**Report Of The November 26, 2012 AC Meeting**

**AGENDA  
ARCHITECTURAL COMMISSION**

**RESCHEDULED REGULAR MEETING**  
Monday, November 26, 2012 at 7:00 P.M.

**REQUEST:** Consideration of a request for signage for Rosin Eye Care, "Building B"; 4196 Route 83 and within the Sunset Grove Development, submitted by Fastsigns Inc.

### RETAIL 'B' WEST ELEVATION

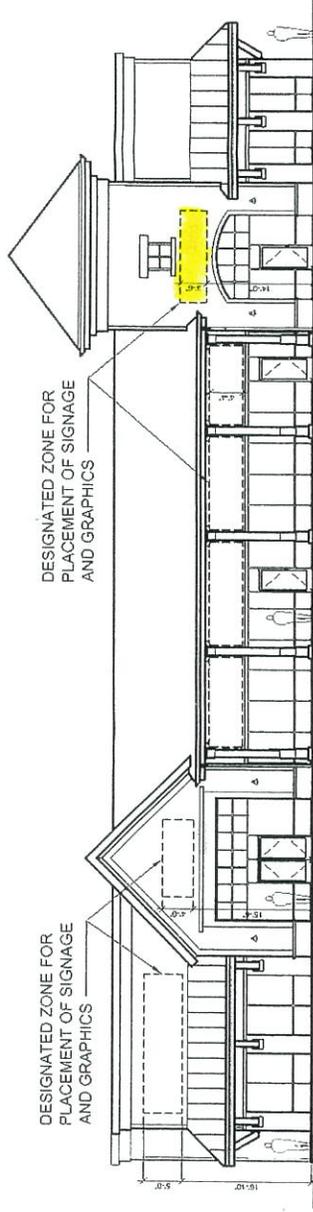
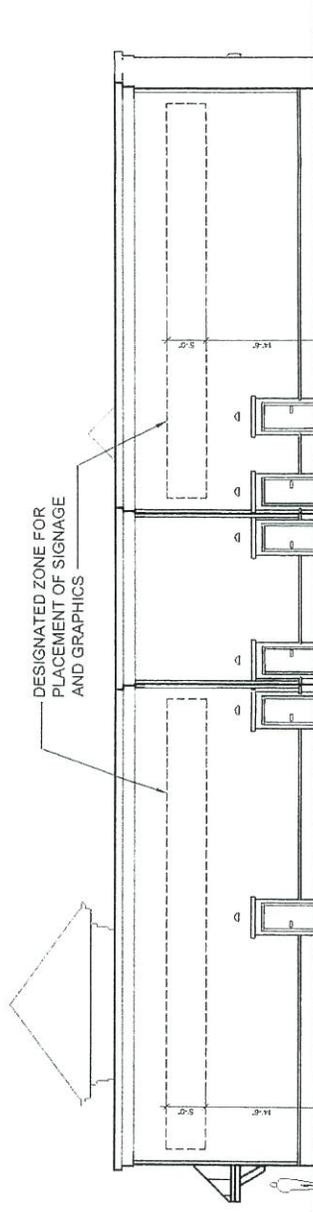
A copy of the approved elevation for "Building B" is attached. As signage relates to this portion of building, the "Rosin Eye Care" signage, as proposed, is in the "Designated Zone for Placement of Signage and Graphics" as indicated on the approved PUD plans.

Petitioner is proposing two wall signs on the south and west facades of "Building B" in the locations approved as the "Designated Zone for Placement of Signage and Graphics". This is consistent with the final PUD approvals.

<b><u>Proposed Sq. Footage</u></b>	<b><u>Sq. Footage Allowed per PUD Approval</u></b>
South Elevation:	4'-6" x 11'-2" (50.4 sq. ft)	98 Sq. ft.
West Elevation:	3' x 7'-6" (22.5 sq. ft.)	29.4 Sq. ft.
East Elevation -	No signage proposed	159.6 Sq. ft.

The proposed signage is within the allowable square footage for such signage as allowed by the PUD approval ordinance.

Signage as proposed is permissible under the approved PUD Ordinance.

# QB1B

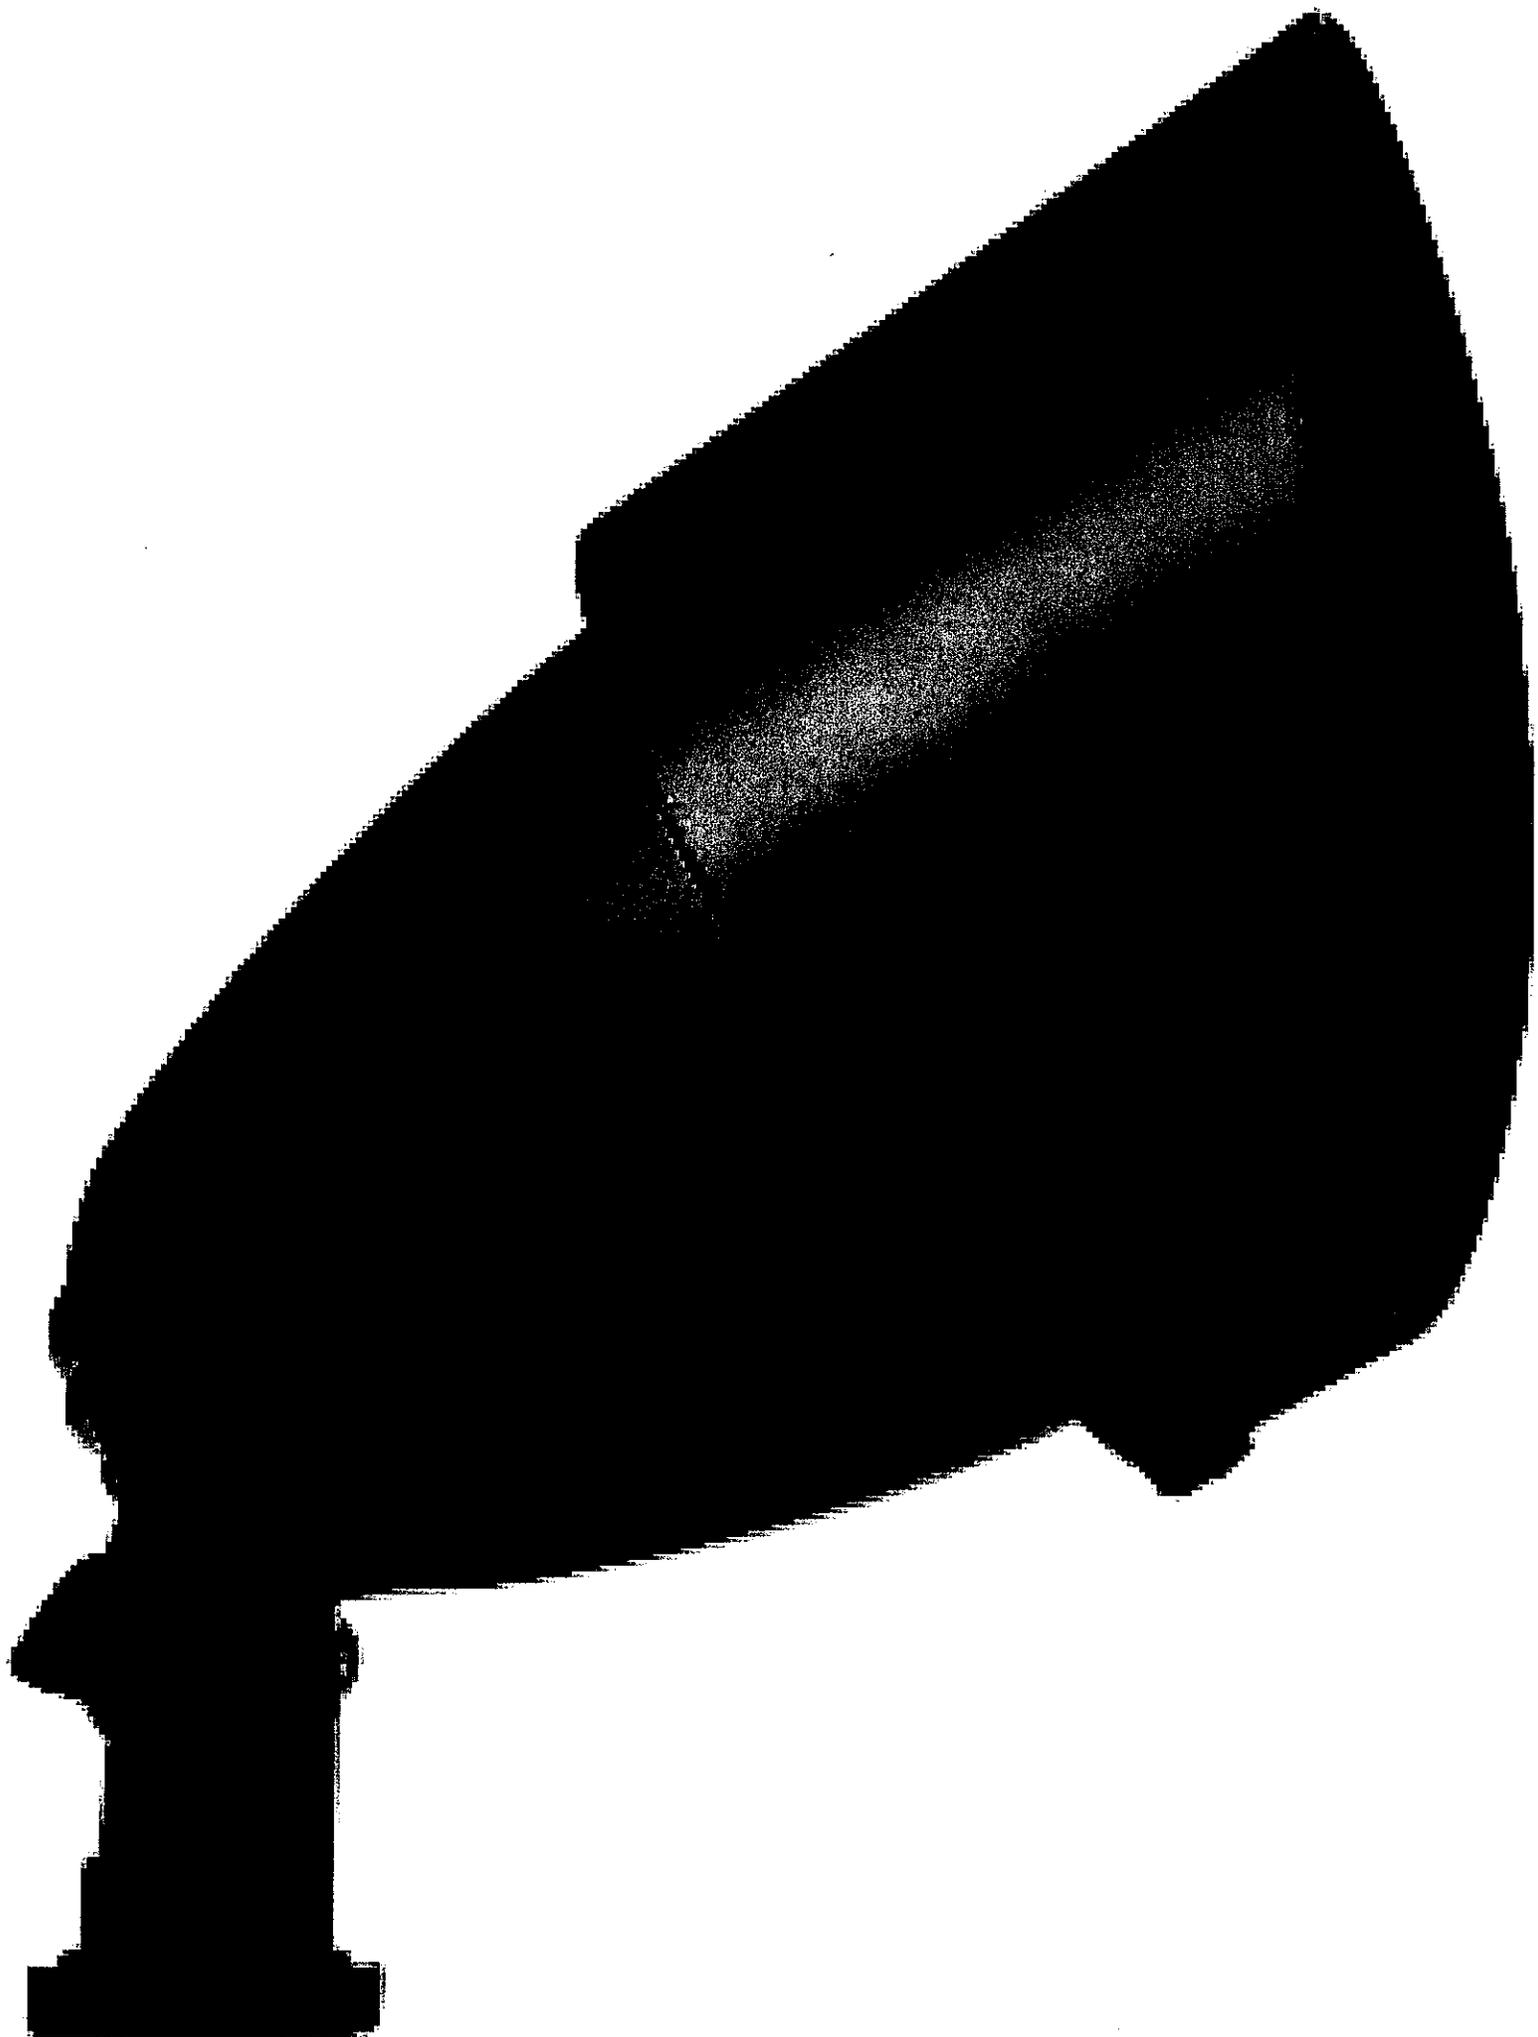
A “Quartz Bullet” floodlight fixture is proposed using a quartz halogen light source. Fixtures are located near the ground, approximately 12” to 18” from grade. Fixtures are black in color and are equipped with a “integra-hood glare shield” designed to minimize glare and direct the light to a specific target. The lighting system is 120 volt system utilizing a 75 watt light bulb.

With the exception of “Holiday Lighting”, “Municipal Parking Lot Lighting” and Private Sign Illumination” all Class 1 lighting requires AB review and approval. A “quartz halogen” light source is proposed for these fixtures. This is permissible with AB approval. Fixtures, other than “19<sup>th</sup> Century Styles, are not permissible. Fixtures with a height of less than fifteen (15’) are allowed; AB approval is required for heights greater than 15 feet. Light sources under 200 watts are permitted; sources over 200 watts are not permitted. Light which spills over or “glare” onto other properties is prohibited

The standard for 19 Century fixtures is in reference to pedestrian lighting and not landscape lighting. The landscape lighting should minimize glare and be integrated into landscape features to be minimally intrusive. As anti-glare shields are included on the fixtures staff and the fixtures are located close to the ground staff questions the need for additional screening of the fixtures in this instance.

The AC should review the request for lighting against the “Test Criteria” listed above as well as the recommendations of the Downtown Design Guidelines. At a minimum the AC needs to approve the use of the quartz halogen light sources. The AC should also determine the appropriateness of the fixtures proposed at the various locations identified on the site plan.
